Road Safety Audit W Spring Valley Road Richardson, TX

NOVEMBER 23, 2022

Facilitated by: Amelia (Millie) Hayes, P.E., PTOE, RSP₂₁
FHWA Texas Division

Figure 5: Some marked crosswalks were not within natural or expected paths

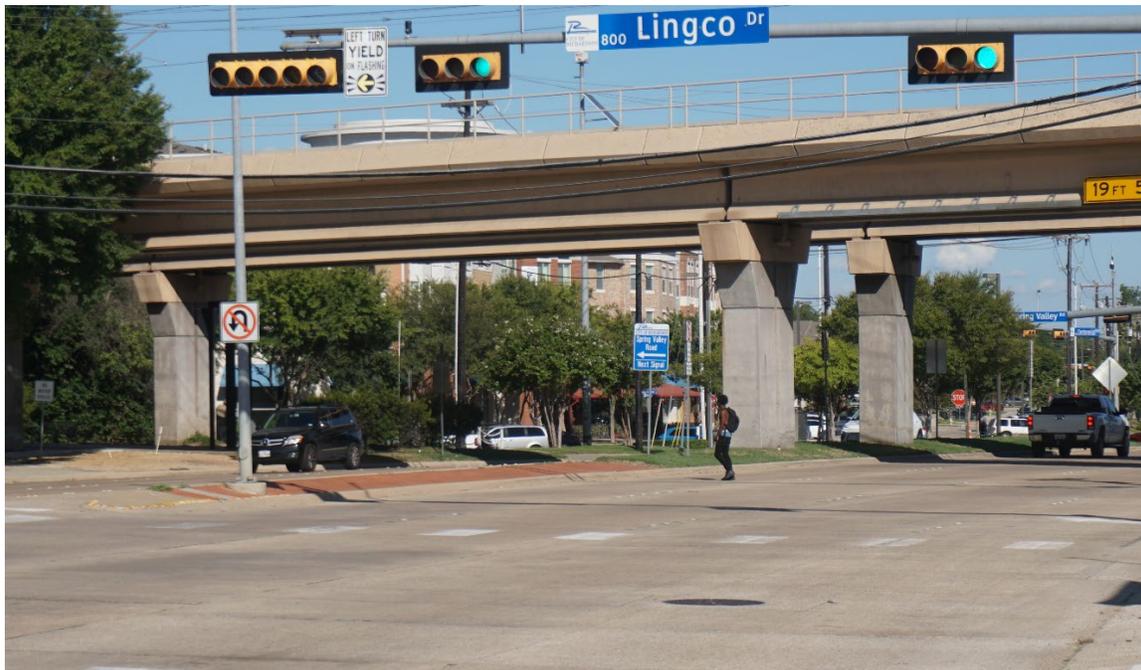
In some locations, marked crosswalks were not located in the desired paths of the pedestrian movements. Pedestrians were naturally taking certain paths between origin and destination, usually choosing the most direct path or crossing when and where gaps in traffic occurred.

Figure 5 is one of several examples of a pedestrian crossing in the natural or expected path, with this crossing movement occurring where the northbound Central Trail had just ended.

Figure 10: Closure of sidewalk with no warning or accessible detour path, located immediately adjacent to bus shelter

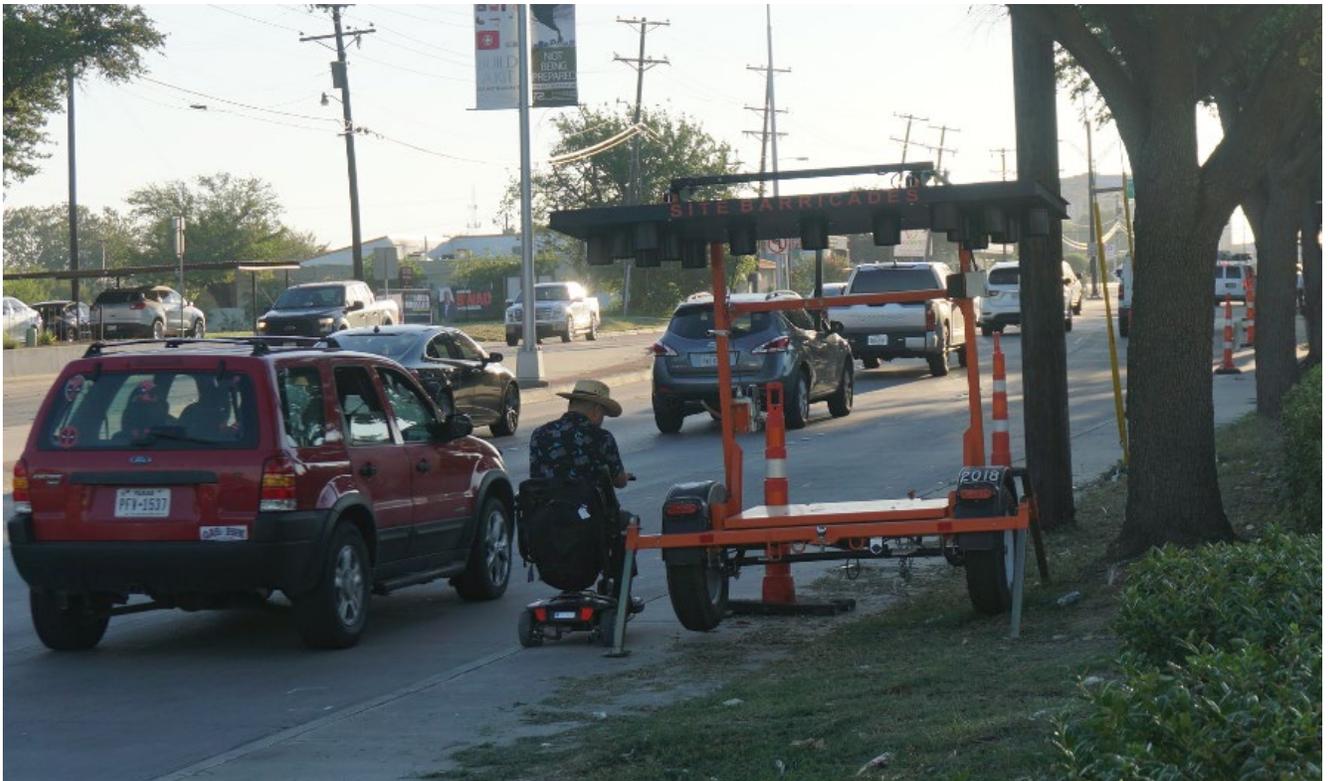
- Consider standards for accessible detour paths for sidewalk closures. The RSA Team observed sidewalk closure and midblock crossing closure with no accessible path and no advance warning.

The RSA Team observed people trying to get around, including one user with a mobility assistance device which made it much more of a challenge. The City should investigate who is responsible for the construction work at these locations. The City should have standards for accessible detour paths for sidewalk closures. Sidewalk closures should be at least as accessible as they were prior to construction. Timeline: Short-term to provide continuous and accessible walking path, and medium-term for updating City standards for sidewalk closures.

Figure 11: Ambiguous pavement area

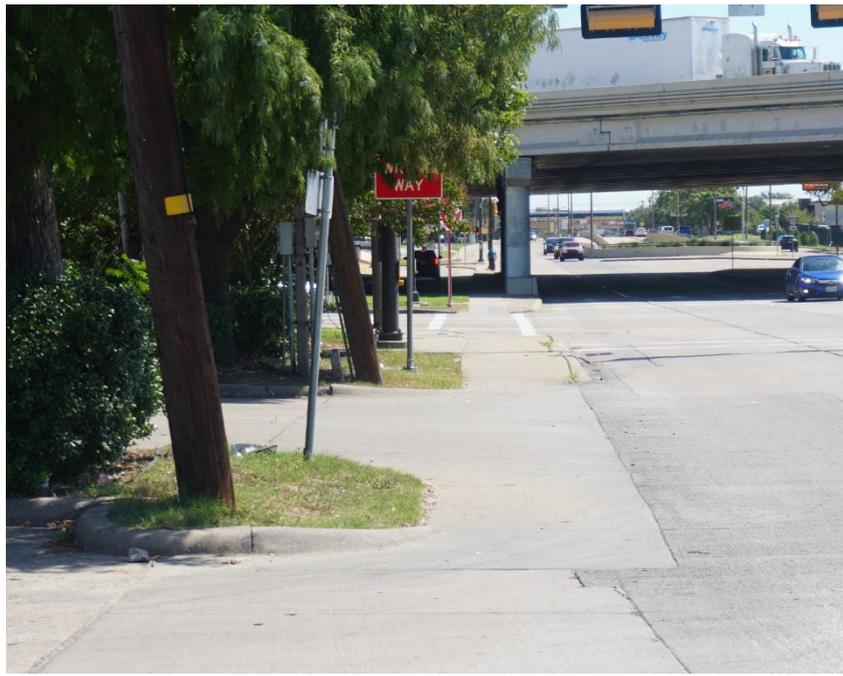
In some locations near US 75, as shown in Figure 11, there were extended lengths where there is no curb separating the sidewalk from motorists. Timeline: Medium- to long-term.

Figure 17: Walking path of students to Spring Valley Road

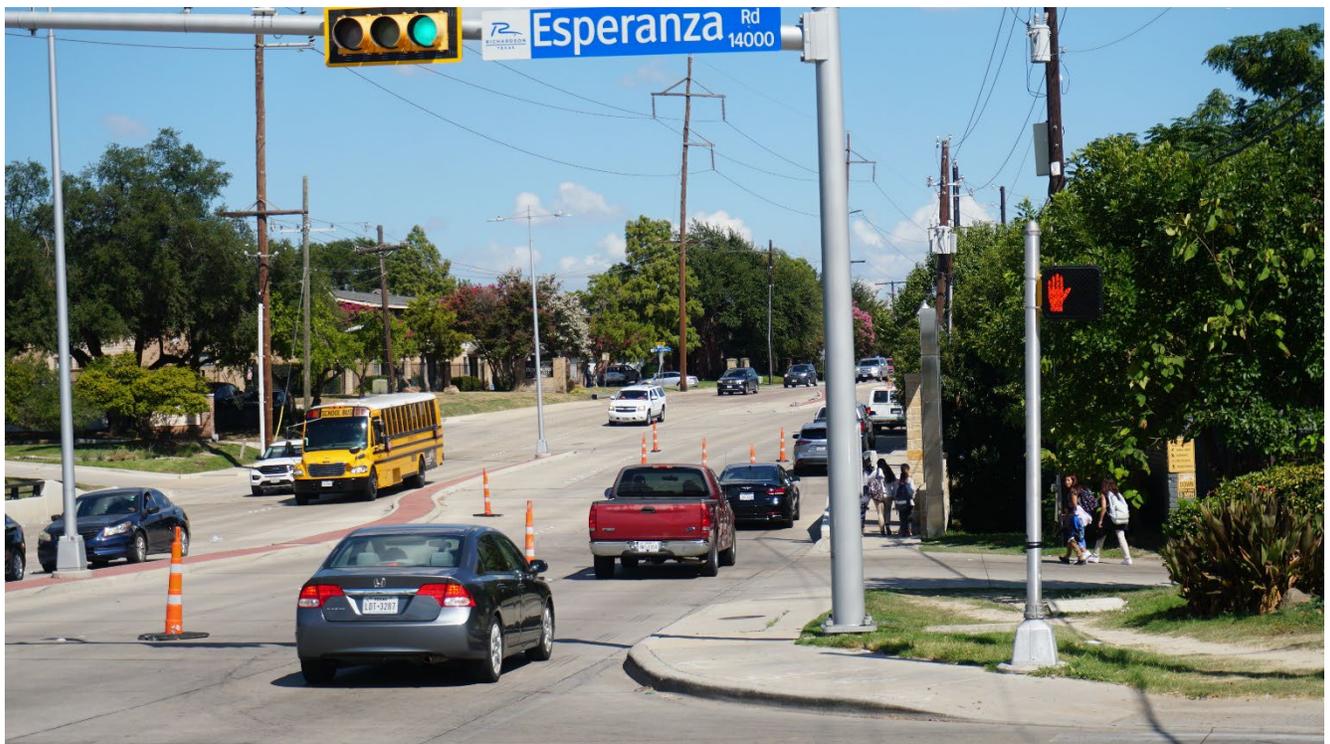
- **Observation:** Marked crosswalks were not provided for all movements. The east side of the intersection had no marked crosswalk, and the RSA Team observed people crossing in this location. Pedestrians, especially in a city near a school, have a reasonable expectation for traditional intersections with marked crosswalks across all legs. Removing a crosswalk because of vehicle conflicts should be the last resort that has been unable to be corrected through other countermeasures. **Recommendation:** Install marked crosswalk with associated ramps, pedestrian signal heads, and pushbuttons. Timeline: Medium-term.
- **Observation:** Traffic circulation around Carolyn Bukhair Elementary could be improved. Most students chose to walk through apartment parking lot instead of using the sidewalk along Esperanza Road.

At both arrival and dismissal, many students and other pedestrians were observed crossing to and from the school on the north of the school at the

Cottonwood Creek Trail junction. City of Dallas school flashers were not operational. **Recommendation:** Consider coordinating with City of Dallas on school traffic circulation, including school flashers and possible marked crosswalk on the north side of the school property. Timeline: Short- to medium-term.

Figure 20: Conflicts at Goldmark Drive

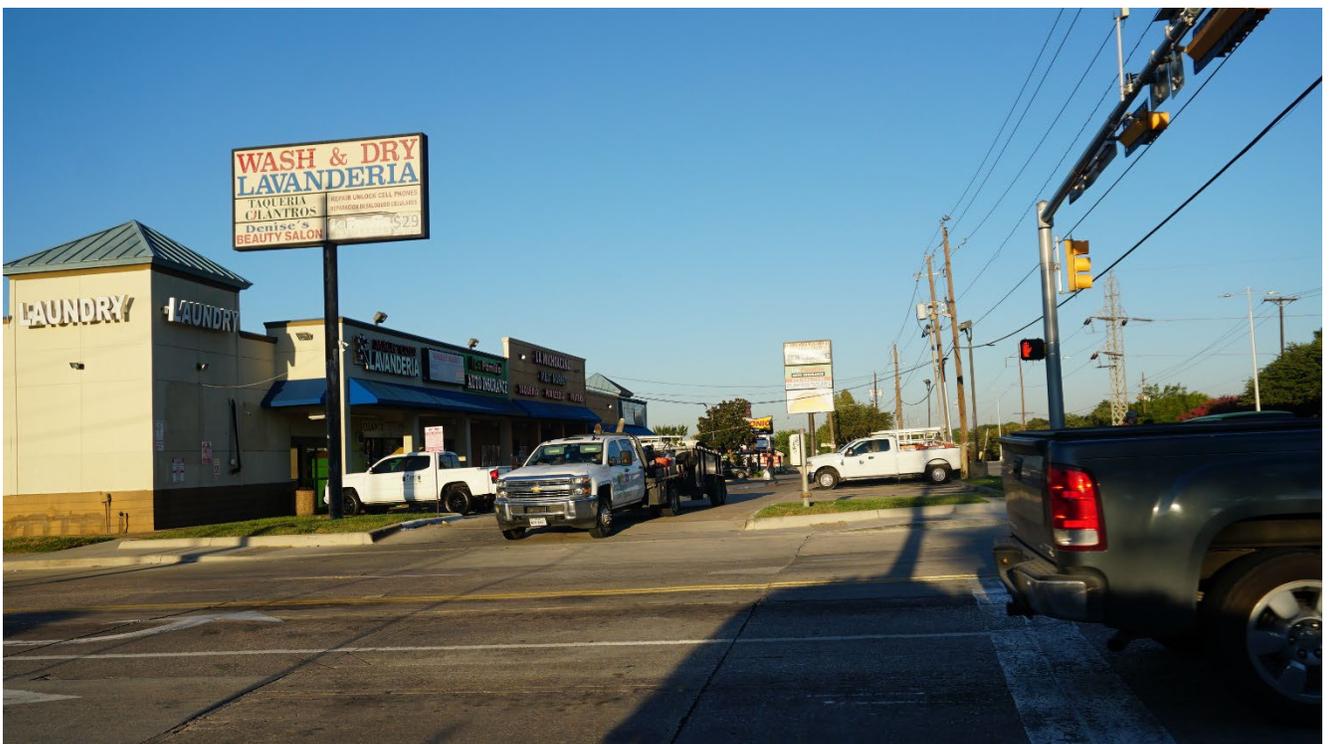
- **Observation:** There is a dual left-turn lane for the movement for westbound Spring Valley Road to southbound Goldmark Drive. The dual left-turn seemed unnecessary during the various times of our field reviews. Large trucks tended to use both lanes, which caused conflicts. **Recommendation:** Consider reconfiguring lane assignments to remove the dual left-turn. If the dual left-turn is still warranted, consider adding an Intersection Lane Control sign. Timeline: Short-term.
- **Observation:** The RSA Team observed multiple conflicts of drivers entering and exiting the commercial development on the southwest quadrant of the intersection onto Goldmark Drive.

Recommendation: Consider coordinating with the City of Dallas to work with the commercial development to potentially close the driveway. Timeline: Medium-term.

Figure 27: Right turn slip lane design (TxDOT)

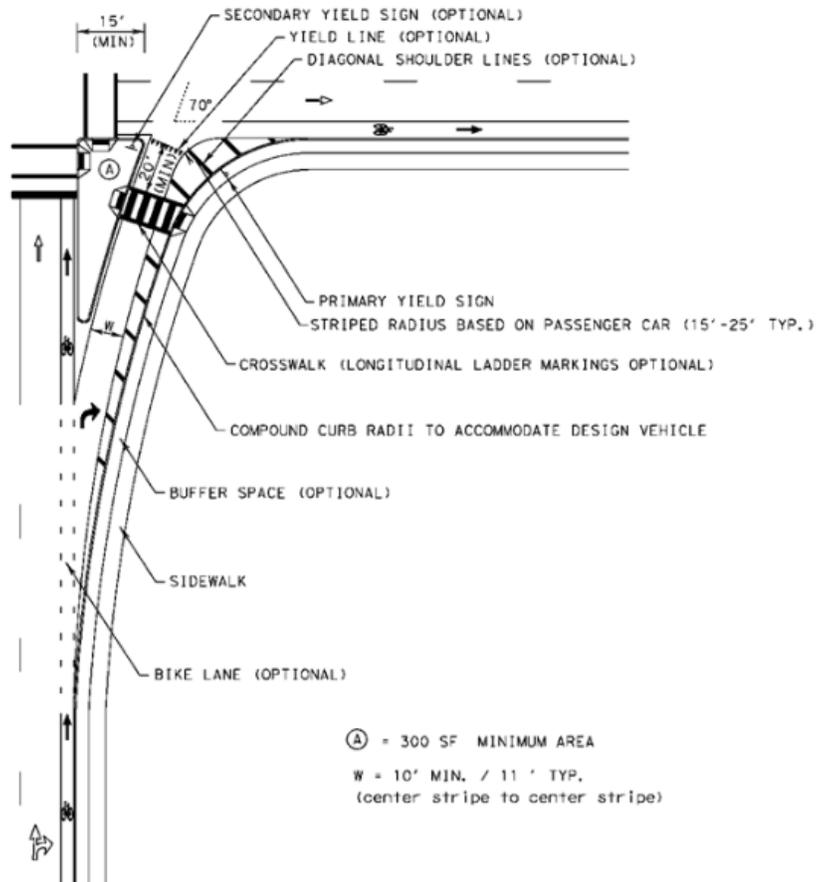
During future improvement projects, the City could also consider [TxDOT's new standard](#) for right turn islands, which tightens the right turn and provides improved visibility for crossing pedestrians. The new standard also features

hatching and pavement markings for passenger vehicle paths, while overall curb return allows for truck off-tracking. Timeline: Medium-term.

Figure 29: Some marked crosswalks were not within natural or expected paths

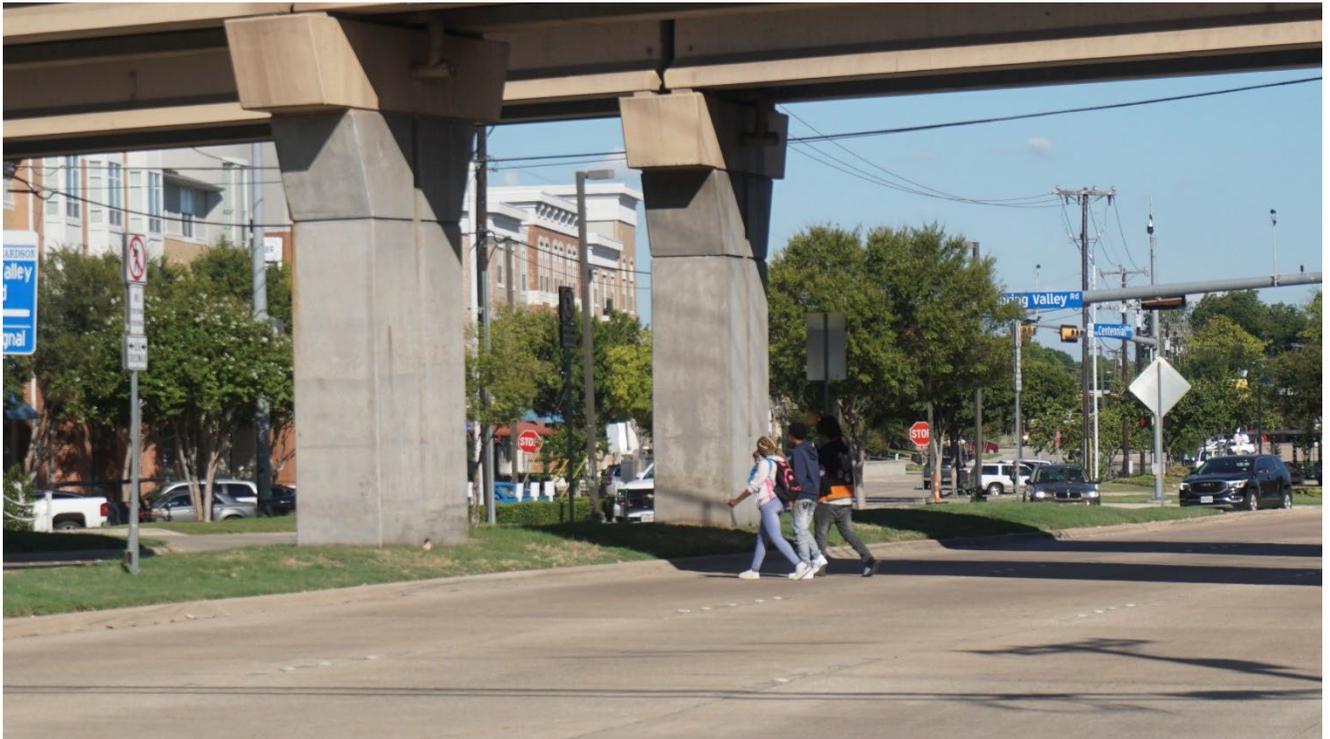
- **Observation:** As discussed in the Primary Concerns section, marked crosswalks were not located in the desired paths of the pedestrian movements. Pedestrians were naturally taking certain paths between origin and destination, and the crosswalks were not within those paths.

In Figure 29, the pedestrians are crossing where the northbound Central Trail had just ended. The RSA Team observed most trail users crossing at that location, and the fencing in place did not appear to be an adequate deterrent. Additionally, signs to route trail users across Spring Valley Road are ambiguous. Central Trail maps show Business Parkway to be the preferred routing. The RSA

Recommendation: Clarify trail continuity and routing. To the maximum extent possible, the preferred routing should continue to have pavement width and markings similar to the trail to feel cohesive to the users. The preferred routing should be clearly indicated on guide signs, whether Business Parkway on the east side or Lingco Drive on the west side. The City should remove the PEDESTRIANS AND BICYCLES PROHIBITED signs on both the north and south sides of Spring Valley Drive, and should keep and maintain the median signs currently in place. The City should also consider adding fencing to the median to further reduce midblock crossings in this location.
